CF/CF/JM
16258
4 July 2017

**RESPONSE TO SUBMISSIONS FOR SSD 5175 MOD 2
EASTERN CREEK BUSINESS HUB (LOT 2)**

Figure 1 – Comparison of approved vs proposed masterplans

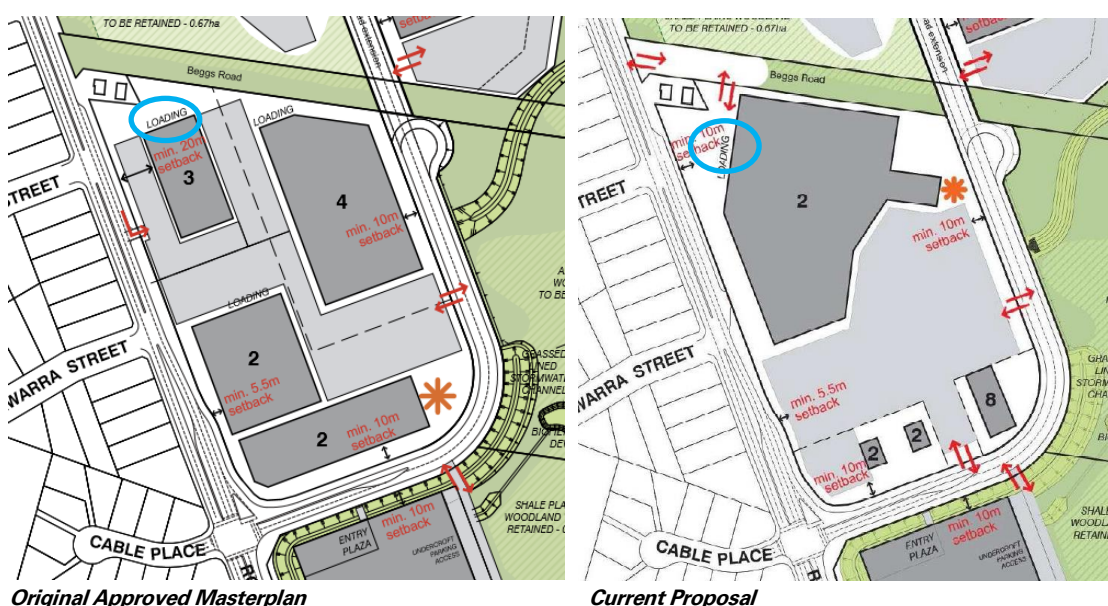
a) *We support the reorientation of the shopping centre towards the Parklands and the separation of truck and car movements. The proposed loading dock, however, is not appropriately located for the following reasons:*

- *It is proposed immediately adjacent to the 2 dwellings on the corner of Rooty Hill Road South and Beggs Road, and is located opposite the low density residential area on Rooty Hill Road South. The loading dock activities will therefore impact on the amenity of these nearby dwellings in terms of visual impact, noise and odour.*

The location of the loading dock is consistent with that approved under the original Concept Plan Masterplan in that a loading area was always envisioned at the north western corner of the site (refer to **Figure 1**). Therefore, the amendments proposed to the loading dock will not result in any additional impacts to adjacent sites. Notwithstanding, the current loading dock location is considered appropriate as any potential amenity impacts on the two dwellings located at the corner of Rooty Hill Road South and Beggs Road, and the residential area on the opposite side of Rooty Hill Road South, can be mitigated as outlined below. It is noted that these matters will be subject to further assessment at the detailed design stage.

Figure 3 – Concept Plan Extract
Source: i2c

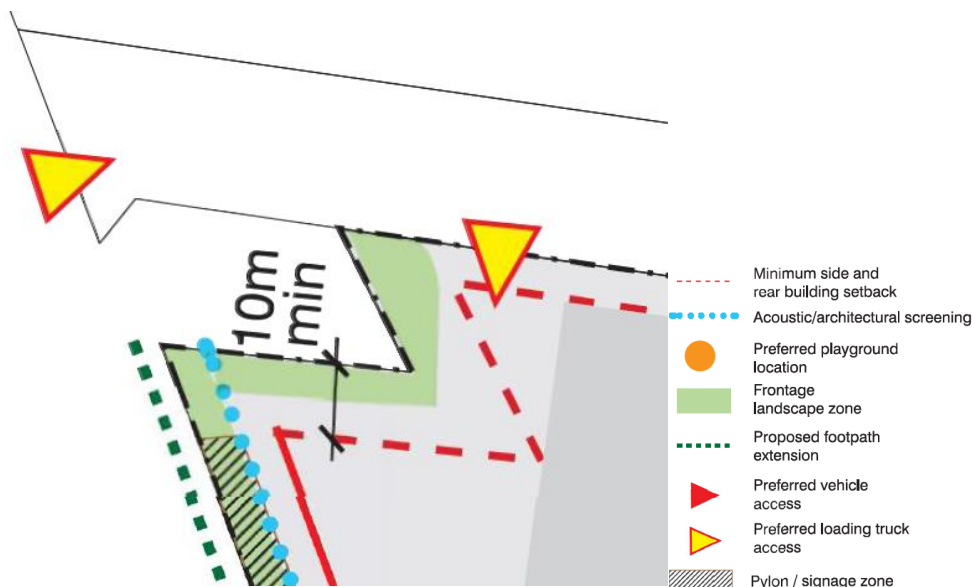
- *While a 5m setback has been provided to Rooty Hill Road South to accommodate screening and dense vegetation, no such allowance has been provided in the north-west corner of the site adjacent to the existing dwellings. A 5m setback is also considered insufficient given the scale of the development and the activities proposed.*

A landscaped setback with a dimension between 5m - 10m is proposed along the loading dock boundary with the adjacent dwellings (refer to **Figure 3**). It is noted that the built form of the retail centre is setback a total of 23m (refer to **Figure 2** above). This plan has been updated within the Design Guidelines at **Attachment B** to reflect this change. As detailed above, the level difference between the sites, the proposed landscaped setback and acoustic wall all ensure that the residential amenity of the dwellings with regard to visual and odour impacts is maintained and will not appropriate outlook is maintained for the adjacent residential dwellings.
